21-008MPR – URBAN MEYER'S PINT HOUSE

Exterior modifications and associated site improvements for an existing restaurant tenant located in Bridge Park.

Zoning Map

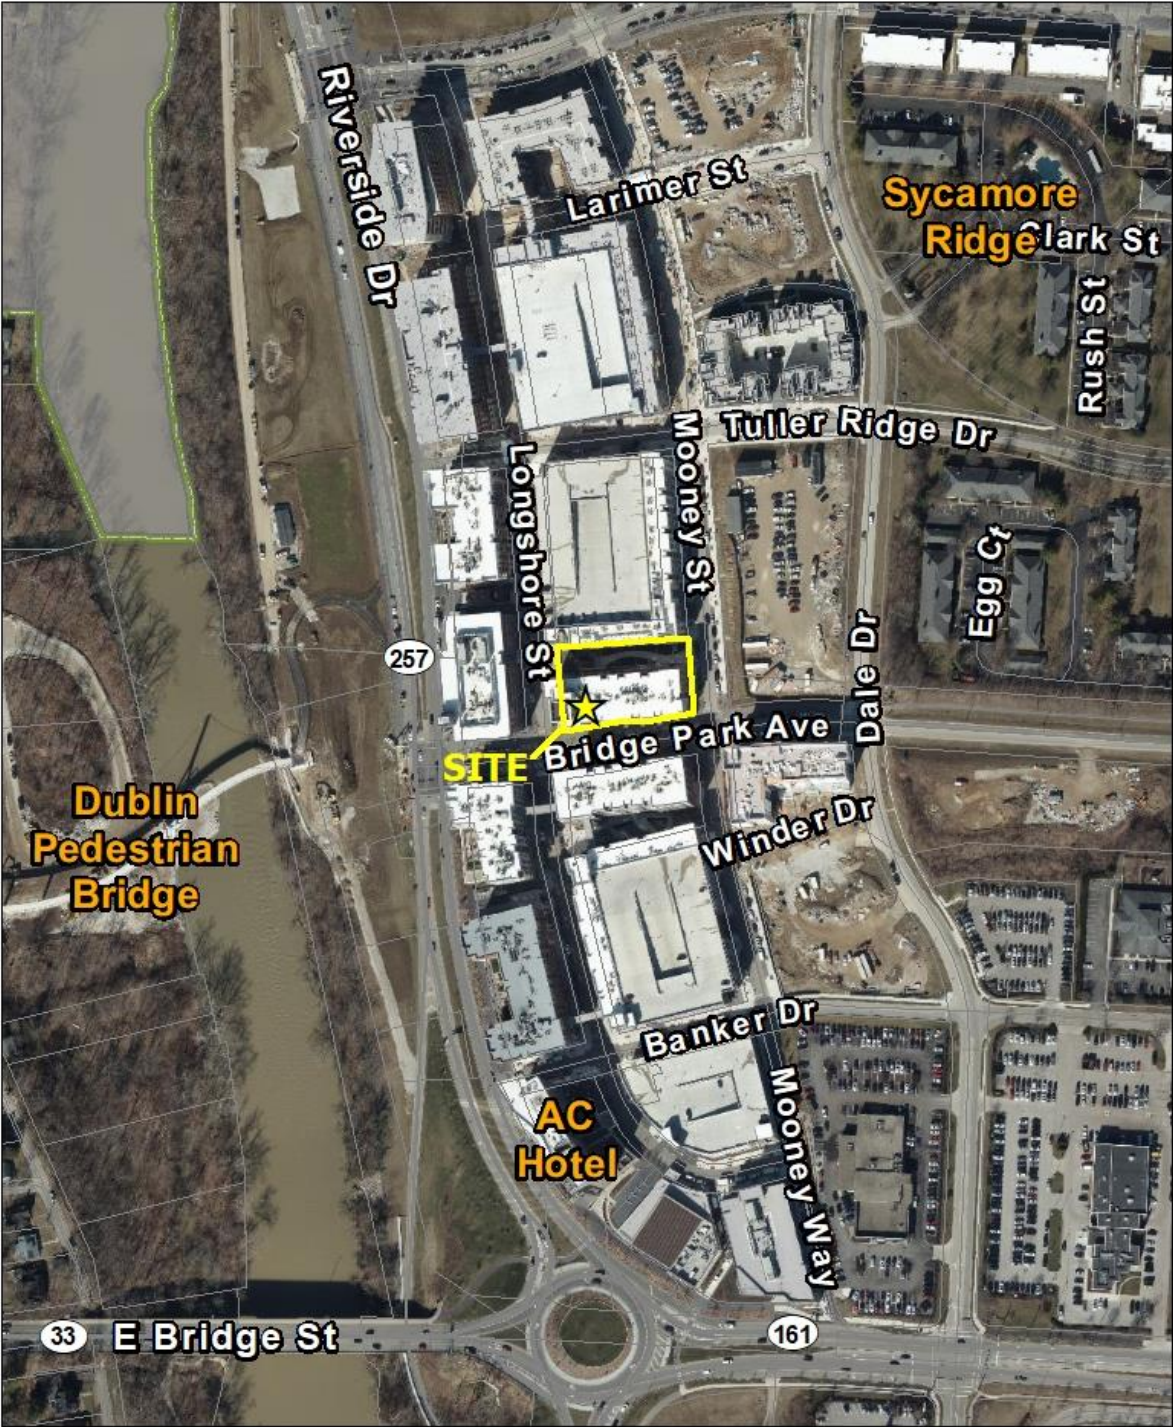
Criteria Met with Conditions. The proposal is largely consistent with the record established by the ART. The proposal creates an opportunity for interaction between the street and the interior of the tenant space. The applicant should make any necessary repairs and cleaning to the brick pavers following the removal of the silo, subject to Staff approval.

- 1) The applicant make any necessary repairs and cleaning to the brick pavers following the removal of the silo, subject to Staff approval.
